City of St. Augustine

Historic Architectural Review Board

A G E N D A

Thursday, June 20, 2019 1:00 p.m.

Date: March 27, 2019
Drawing Scale: 1" = 10' (KSR)
Designed By: Earthworks, Inc
Revisions:

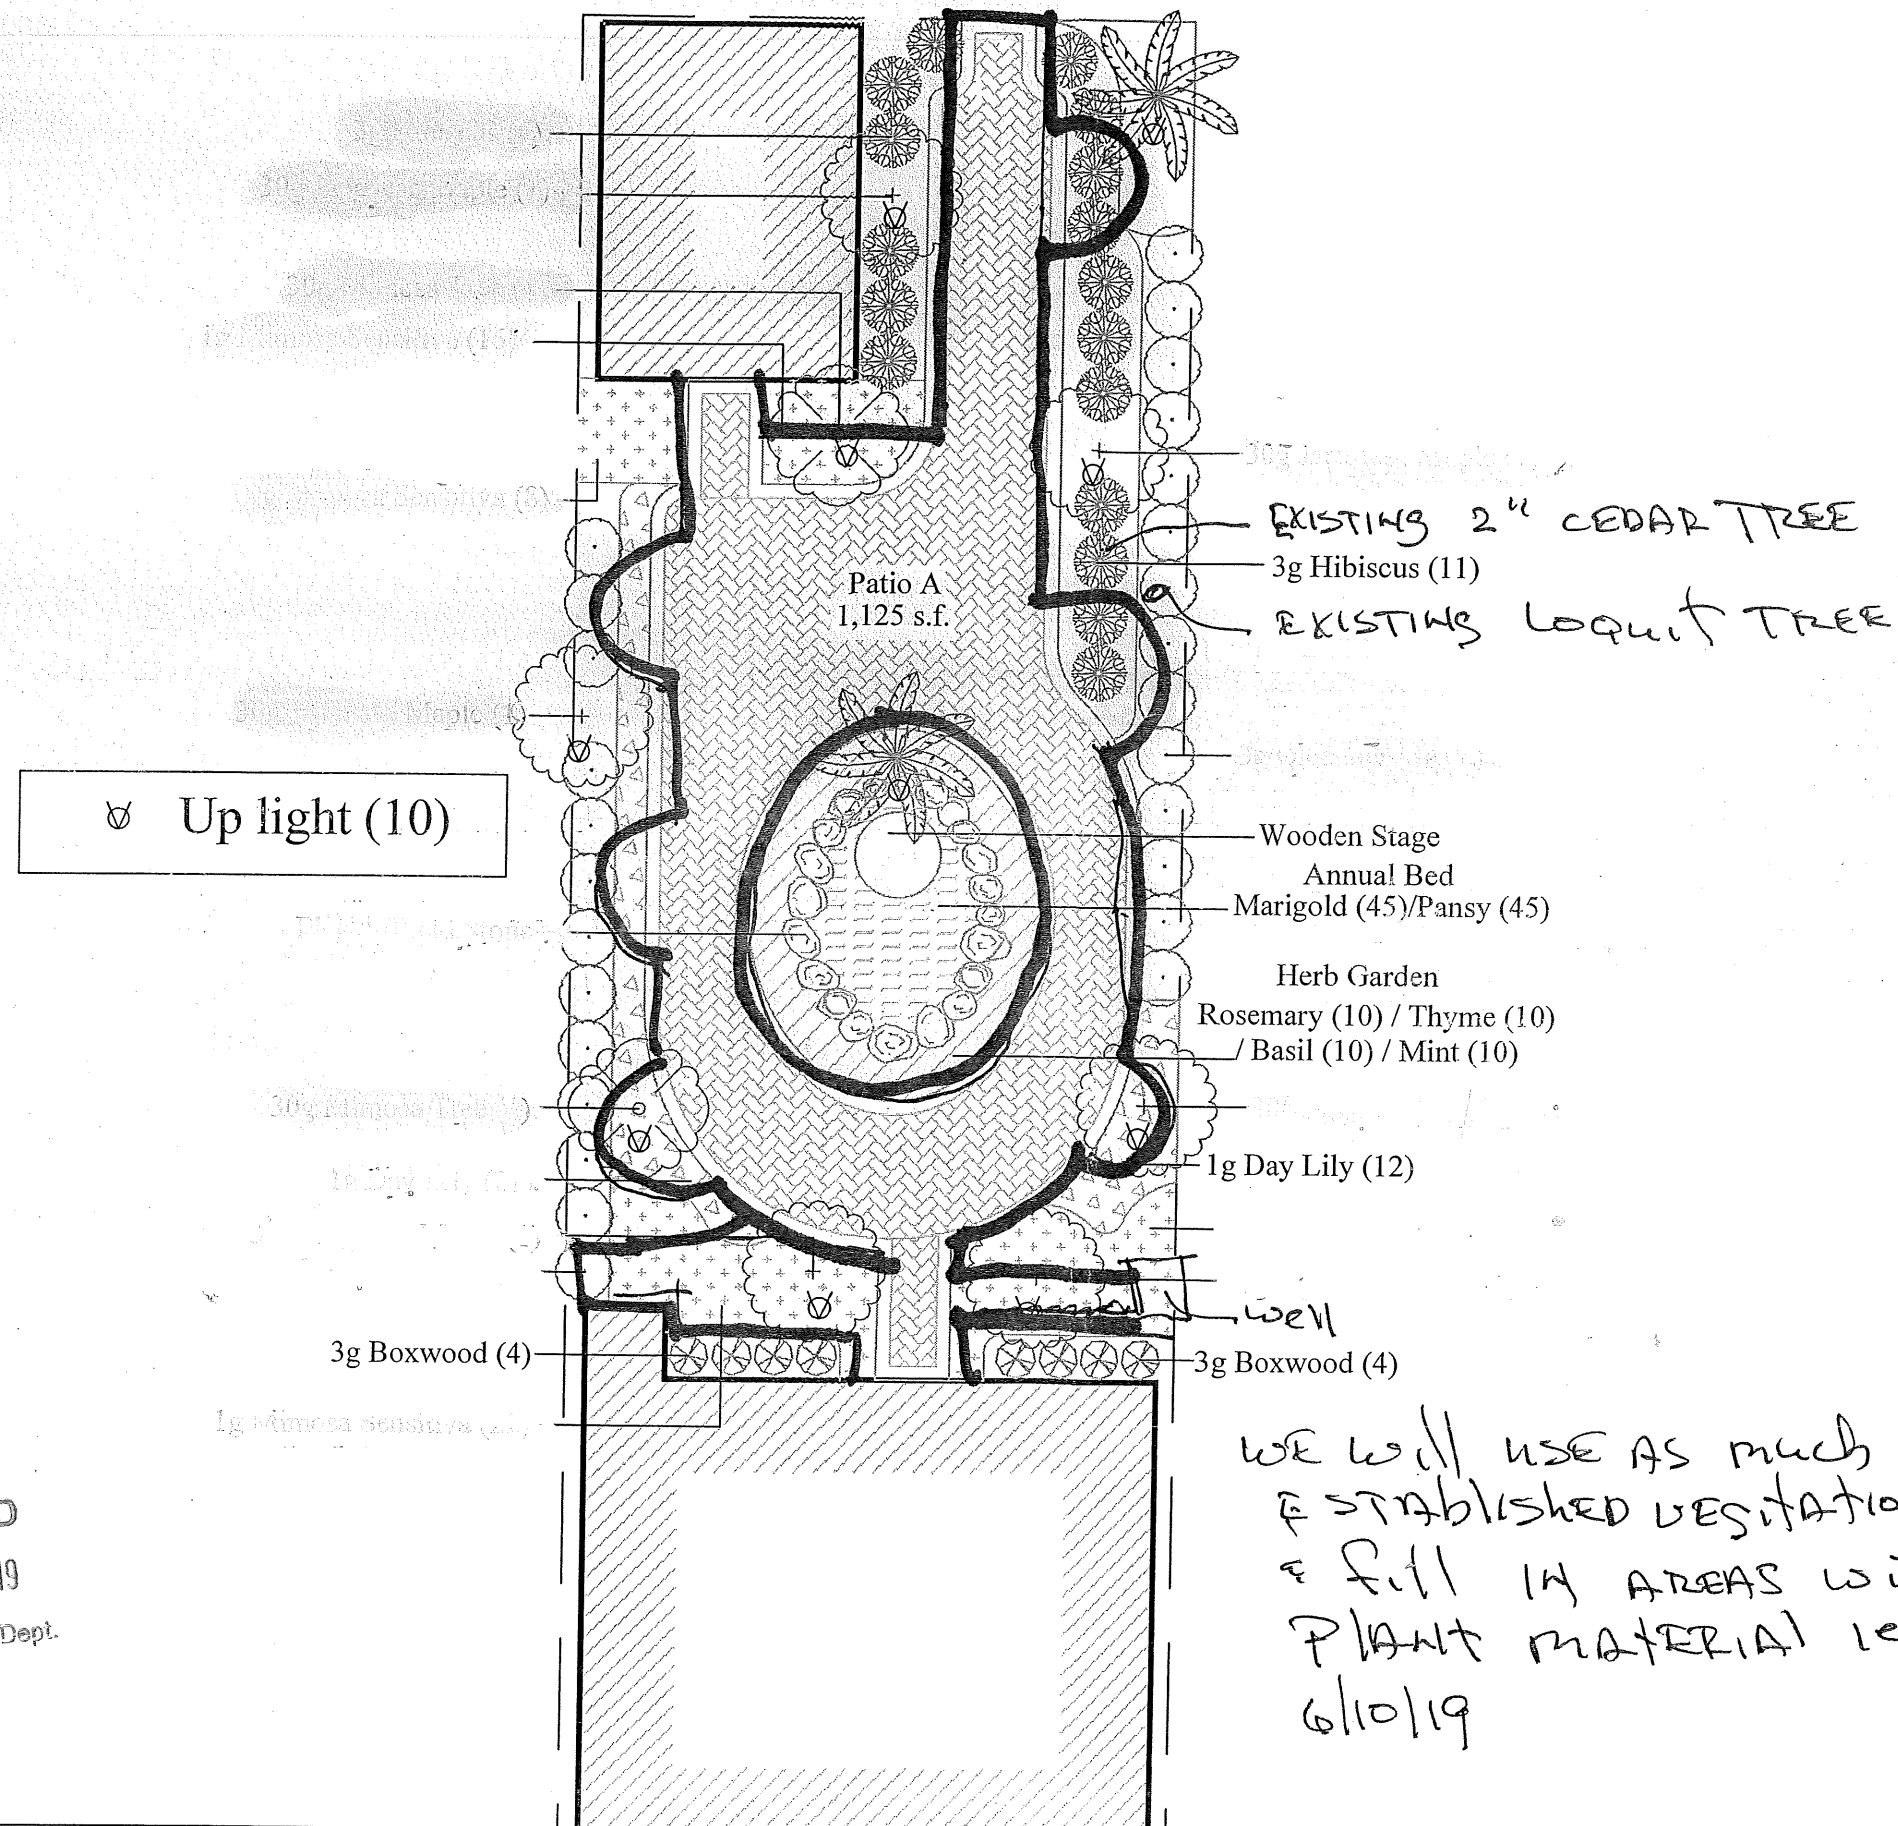
- The applicant should clarify if the blackline on the design is the existing layout of the bricks or a new proposed layout.
- An example of a brick was provided with a previous design. The applicant will need to clarify if the same bricks will be used in the new design.

- The Wedelia is not found on the Historic Plant Materials List and is an exotic invasive species. If the applicant intends to add additional plants, staff can approve them if they are listed on the pre-approved list.

- Reusing the existing coquina will be appropriate. According to a letter provided with the new material, it will be used around plant beds, and the design shows it around the central bed. Additional information should be provided if the coquina will be placed elsewhere.

- Proposed lighting was submitted with a previous design, which showed them being placed within plant bedding. If the applicant intends to place the lighting in a new location or intends to use a new type of lighting, this information will need to be provided.

- The applicant mentioned using clay terracotta planters for new plants. A photograph or drawing of the proposed planters should be provided to determine if they are appropriate.

- 1) The applicant confirm the lighting details to include the light output.
- 2) The applicant provides the brick pattern to staff.
- 3) The applicant removes the exotic, non-native plant and replace it with a native beach flower (*Helianthus debilis*) or another pre-approved plant.
- 4) The applicant provides a plant list for the proposed potted plants, which should be listed in the AGHP or native to the Spanish Colonial period.
